ADDENDUM No. 1 ISSUED BY

CDA Engineering
6 Larch Avenue, Ste 401
Wilmington DE 19804

PRE-BID MEETING MINUTES

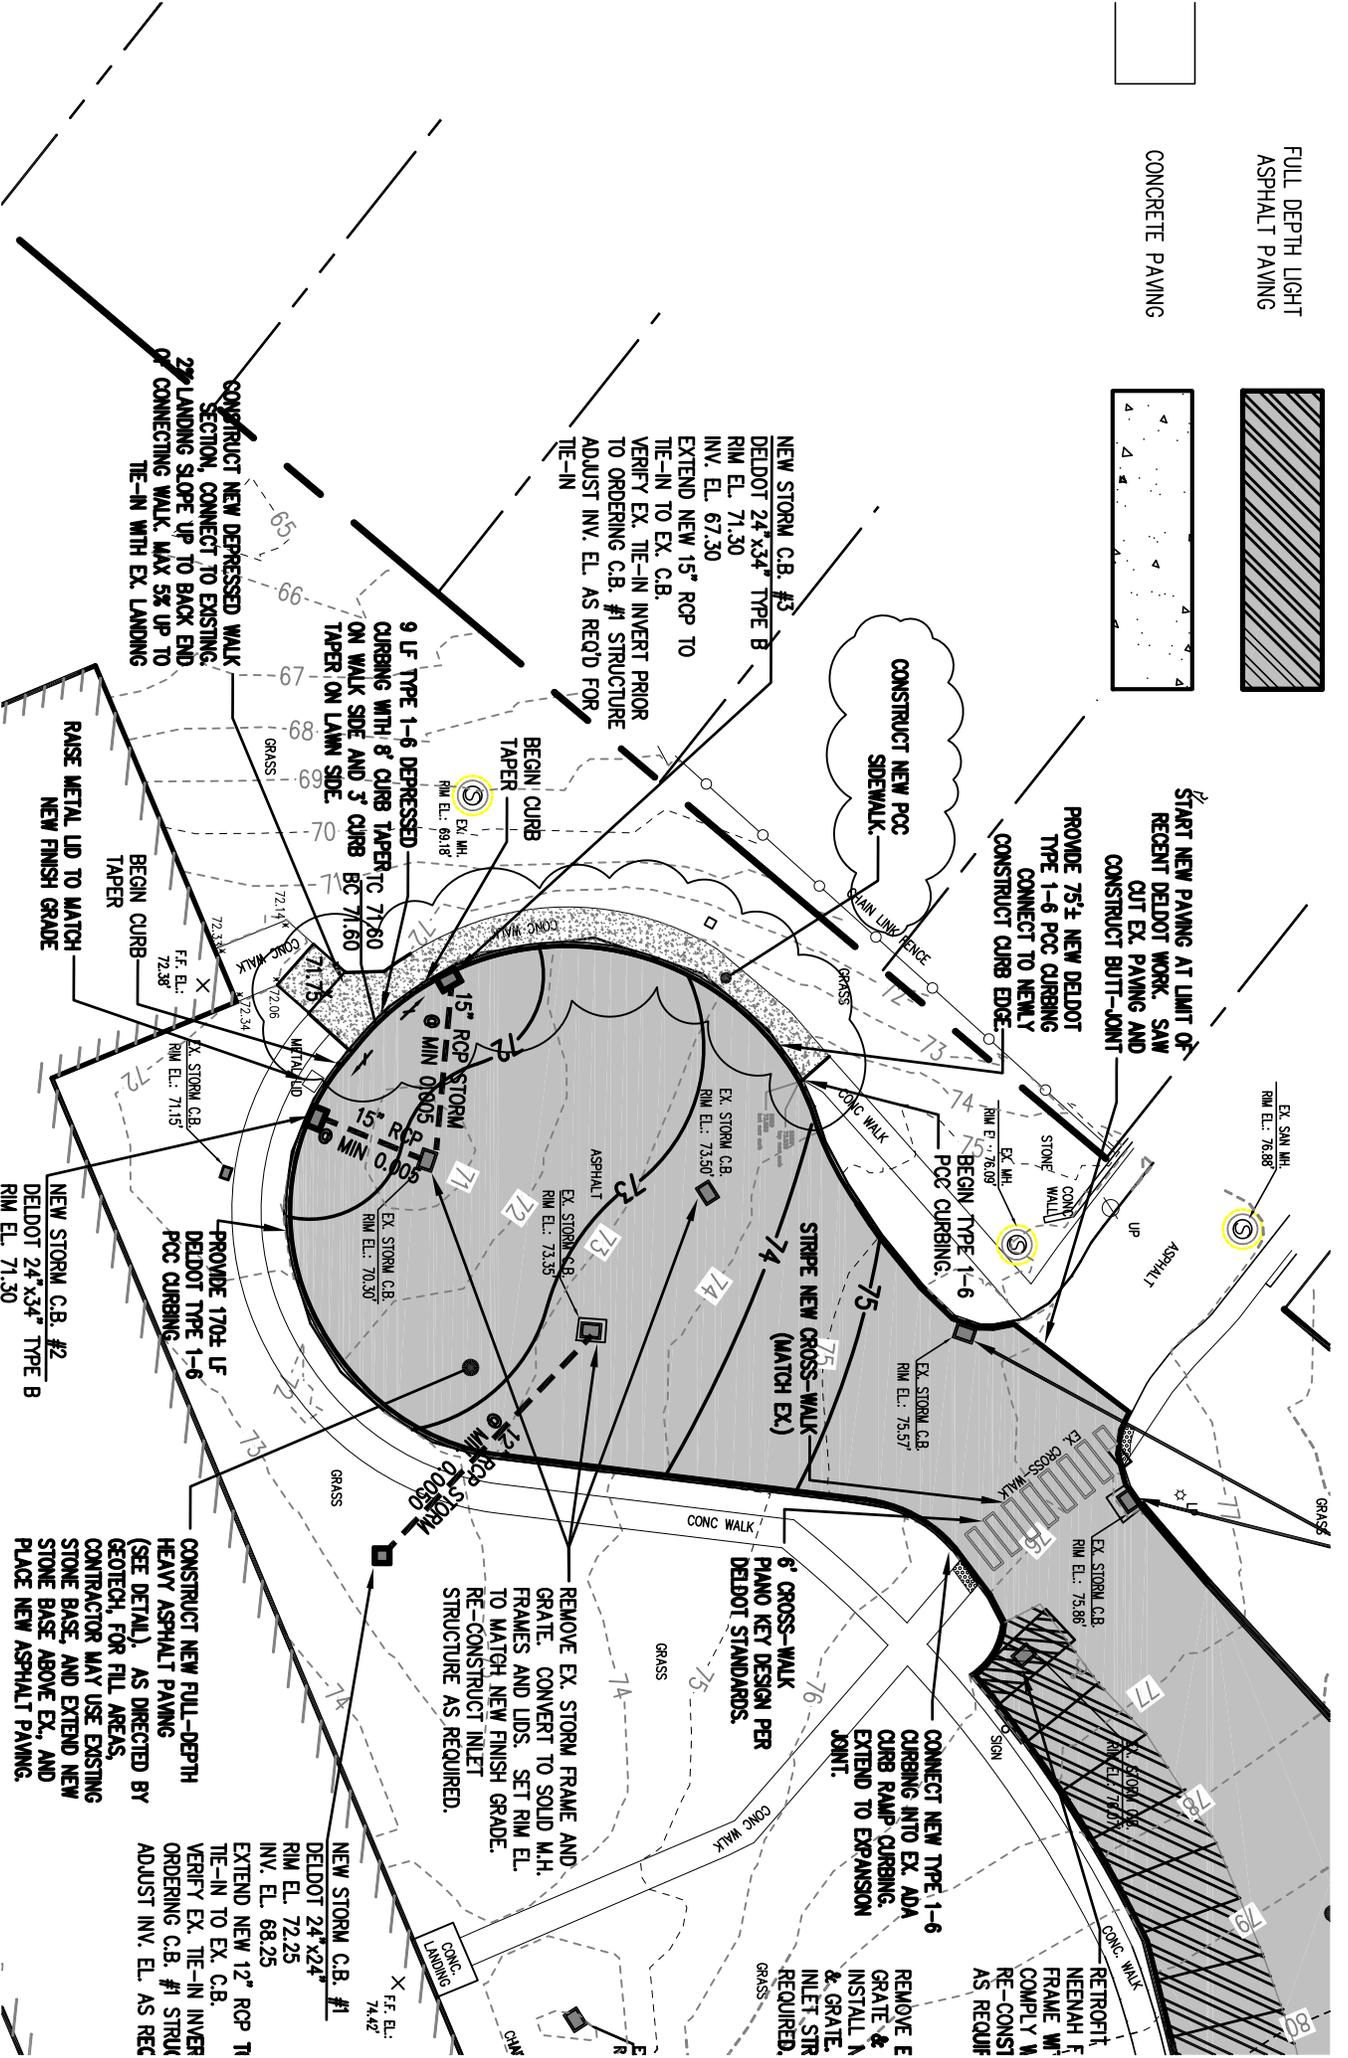
3. Payment of prevailing wages is required on the project. A list of the current prevailing wages is contained in the bid documents.
4. The drawings originally showed the concrete area around the flag pole in front of the school and the four (4) adjacent parking stalls as being repaved. These two areas are not part of the demolition and shall remain as concrete. (See attachment)

Q: The 75' of curbing along the western edge of the lower turn around circle is integrally cast to the sidewalk. Should both curb and sidewalk be replaced?

A: Yes. The drawings have been edited to reflect the replacement of both the curb and sidewalk. (See attachment)
